**ADDENDUM 4 - WINDOW SPECIFICATIONS
ROOM 4 - RECEPTION OFFICE**

ADDENDUM 4 - WINDOW SPECIFICATIONS

ROOM 1 - ADMINISTRATION OFFICE

PROJECT:	Building "A" Remodel and Building Renovations	RFI NO.:	PB-004
OWNER:	West Side Health Care District	DATE:	07/07/2025
CONTRACTOR:	Black/Hall Construction, Inc. P.O. Box 445 Taft, CA 93268

D Windows W03 - Room 4, Reception Office

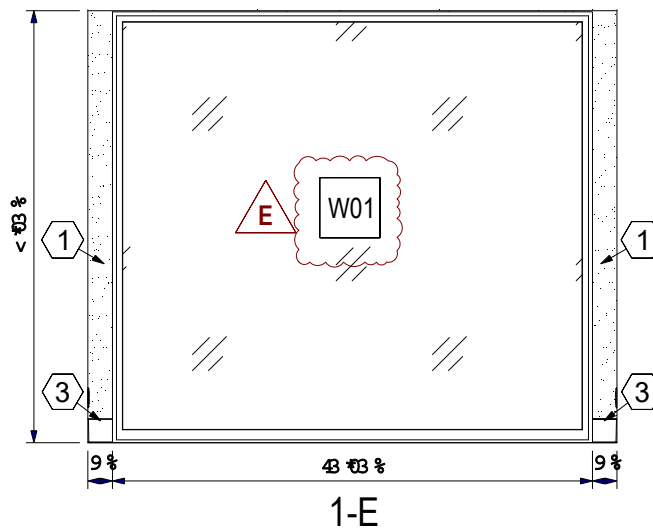
Interior Fire-Rated Windows:

Provide a 1-hour fire-rated interior window assembly, tested and labeled in accordance with NFPA 257 or UL 9. Assembly shall include:

- **Fire-rated glazing:** Clear, safety-rated glass compliant with ASTM C1048, listed for fire-resistance and impact safety where required by code.
- **Fire-rated hollow metal frame:** UL-listed, welded hollow metal frame with a fire-resistance rating equal to or greater than the glazing.
- Entire assembly shall be installed per the manufacturer's tested and listed system, in compliance with IBC Section 716.

E Windows W01 - Room 1, Administration Office

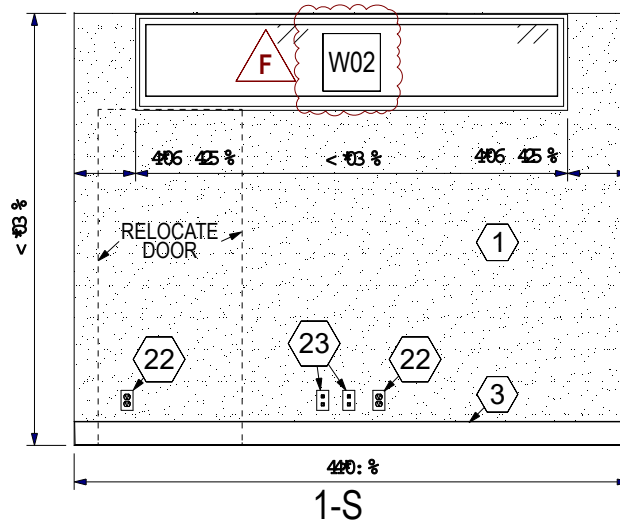
Interior One-Way Storefront Window:

- Provide interior storefront-type glazing system with one-way visibility, allowing visual access from administration office to lobby only.
- System shall include:
 - Aluminum storefront framing to match adjacent glazing systems in profile and finish.
 - One-way reflective glazing or mirror film applied to interior face, designed to provide privacy while allowing observation from the opposite side.
 - Glazing shall be tempered or laminated safety glass per ANSI Z97.1 and CPSC 16 CFR 1201.
 - Install per manufacturer's recommendations for film or coated glass orientation and performance.
